# TECHNICAL SERVICE BULLETIN

## Ting Or Click Noise From The Front Or Rear Wheel Hub When Accelerating, Applying Brakes Or When Shifting Between Drive And Reverse

**25-2044**

This bulletin supersedes 22-2395. Reason for update: Revised Service Procedure

Figure 1

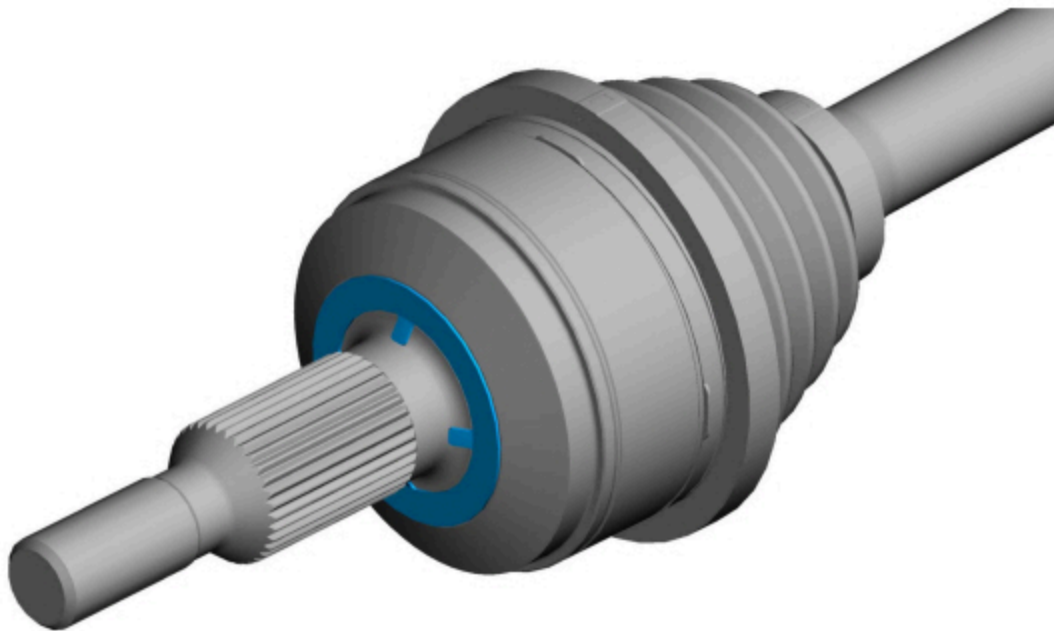
**Issue:** Some of the vehicles listed in the Model statement above may exhibit a ting or click noise from the front or rear wheel hubs when accelerating, applying brakes or when shifting between drive and reverse. This condition may be caused by a stick/slip condition between the hub and halfshaft interface.

1. Drive the vehicle to verify which hub or hubs are exhibiting the concern.
  - (1). Accelerate/apply brakes or shift from forward to reverse.
2. Inspect the affected wheel hub to axle shaft interface for an anti-ting washer (Figure 1) by removing the affected wheel hub.

**Action:** For vehicles that meet all of the criteria in the Issue and Model statements, follow the Service Procedure to install an anti-ting washer between the wheel hub and axle shaft.

- (1). For front wheel hubs, refer to WSM Section 204-01B Front Suspension - LHD 4WD > Removal and Installation > Front Wheel Bearing and Wheel Hub - Electric.
  - (2). For rear wheel hubs, refer to WSM Section 204-02 Rear Suspension > Removal and Installation > Wheel Bearing and Wheel Hub - Electric.
3. Does the affected axle shaft have an anti-ting washer installed?
    - (1). Yes - proceed to Step 4.
    - (2). No - install an anti-ting washer on the affected axle shaft (Figure 1) then proceed to Step 4.
  4. Reassemble the vehicle.
    - (1). For front wheel hubs, refer to WSM Section 204-01B Front Suspension - LHD 4WD > Removal and Installation > Front Wheel Bearing and Wheel Hub - Electric.
